# *Camden Residents' Action Group*

Nicholas Clarke  
Senior Planner  
Camden Council  
1 February 2018

## **Re: McDonald's DA 2017/1159/1**

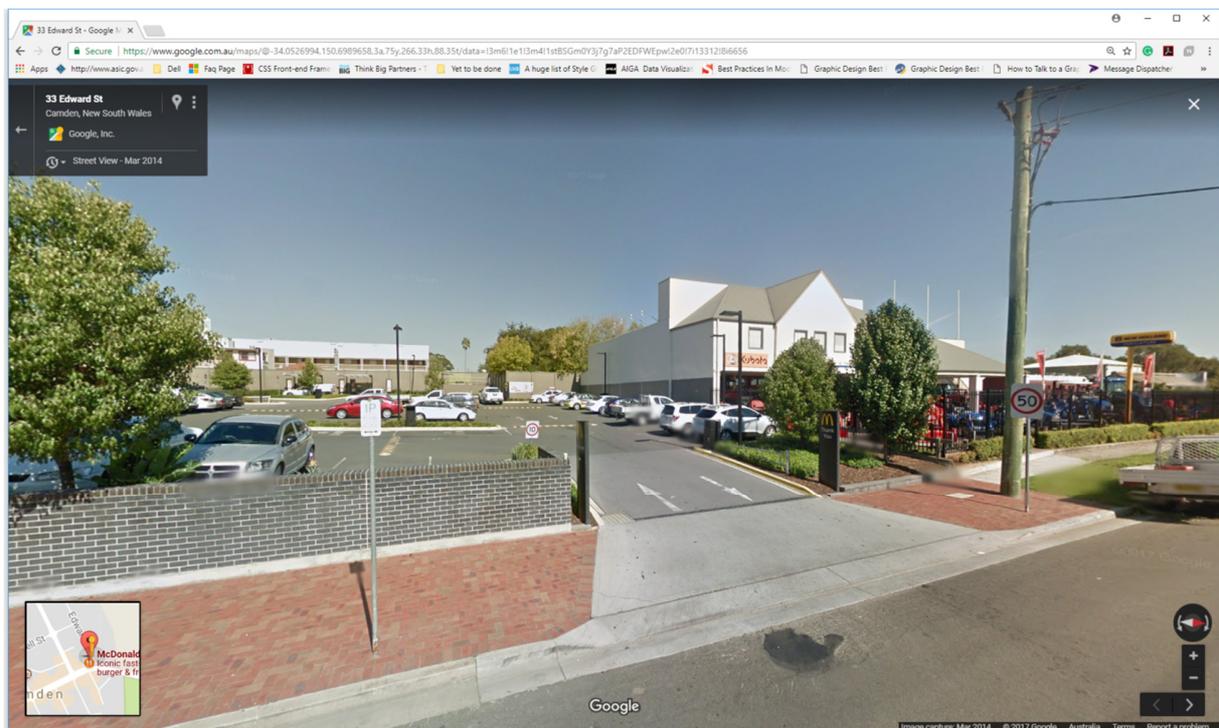
Whilst it may be arguable in a narrower sense that the proposed 6m pylon sign is not entirely incompatible with other signage in the vicinity it would be very difficult to argue that it is compatible with a heritage conservation area and that it is not more obtrusive than what is there now at the entrance.

In any case it is of course not a valid argument to point to other signage that also may be inappropriate. As addressed above this is not the wording or intention of the DCP and SEPP. It is also not clear what signs are being referred to as being compatible with a 6m tall, 1.524m wide pylon sign. The sign that is specifically mentioned in the response is assumed to be the tall thin sign at Camden Tractors to the right in the above photo.

We are yet to be convinced that this sign is as obtrusive as that proposed by McDonald's.
